- Subject** ▶ Change of Torque Limiter Complete
- For Models** ▶ HR3000C, HR3550C, HR4040C, HR4500C
- Country** ▶ All countries
- Description** ▶ Adhesive has been applied to Pin 4 in Torque Limiter Complete to prevent the Pin 4 from coming out of place.

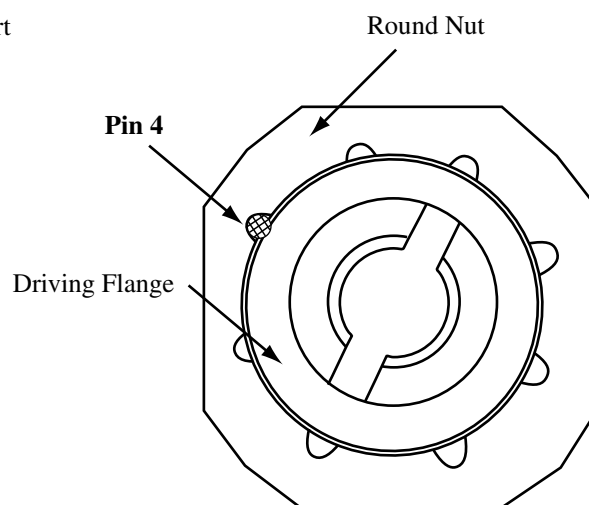
Torque Limiter without Pin 4 may cause a Round Nut to rotate, resulting in the torque out of presetting. To avoid such trouble, this addition of adhesive has been made. (However, Pin 4 in the Torque Limiter Complete which is installed on Rotary Hammers does not come out of place. Accordingly, this change is applicable to Torque Limiter as a replacement part only.)

Note: Regarding Torque Limiter Complete as a replacement part please check the Torque Limiter for Pin 4's presence. When Pin 4 is not present, insert Pin 4 in the portion where the notch on the Driving Nut of the Torque Limiter meets that of a Round Nut of the Torque Limiter as shown on right. Caution: Be careful not to drop Pin 4 at the time of repairing. Please use LOC TITE 603 (Part No. 045047-7A) as a adhesive.

Item No.	Current part		Q'ty	I/C	New part		Q'ty	Note
HR3000C, HR3550C: 104	Torque Limiter Complete 151692-9		1	Yes	Torque Limiter Complete 152955-6		1	
HR4040C: 084	Torque Limiter Complete 150860-1		1	Yes	Torque Limiter Complete 159947-6		1	
HR4500C: 070	Torque Limiter Complete 152763-5		1	Yes	Torque Limiter Complete 152954-8		1
